31/6-94A 10405 Montgomery Avenue
Kensington Historic District

LAP Minutes

APPLICATION FOR HISTORIC AREA WORK PERMIT

LIVELY OFFICE
10405 MONTGOMERY AVENUE
KENSINGTON, MARYLAND

WINDOW MANUFACTURER SPECIFICATIONS

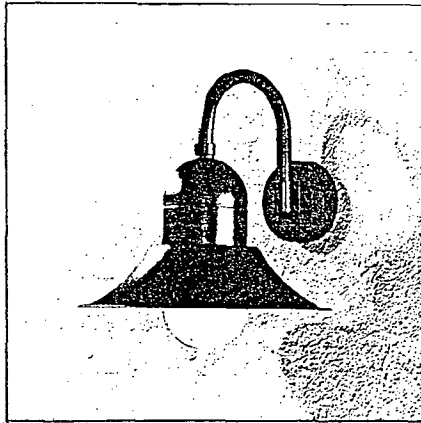
1. There was general agreement that false muntins would be undesirable, but replacement of windows with material other than steel was not considered objectionable. The present windows, while in relatively good shape, are an unusual configuration with a central glass panel opening inward. This would be hard to duplicate.

However, the staff always finds cases involving steel windows to be difficult. The windows are not desirable by today's standards from the perspective of either function or energy efficiency. Interior storms are an option, but not one that commercial owners and tenants embrace. If this structure had a strong industrial character or identity, the staff would more strongly urge the retention of the windows.

While urging retention, the staff would recommend to the Commission that a replacement aluminum window that reproduced the muntin configuration, thickness, and projecting profile would be a passably acceptable alternative. The staff has asked the applicant to come to the HPC meeting prepared to discuss metal window alternatives to the proposed vinyl-clad windows, which the staff finds to be too residential in character. (If the HPC finds the vinyl windows acceptable, a projecting muntin should be used.)

With the condition that the steel windows be replaced only with a metal window of appropriate configuration, dimension, and profile as discussed above, the staff recommends that the Commission find the proposal consistent with the purposes of Chapter 24A, particularly 24A-8(b)1:
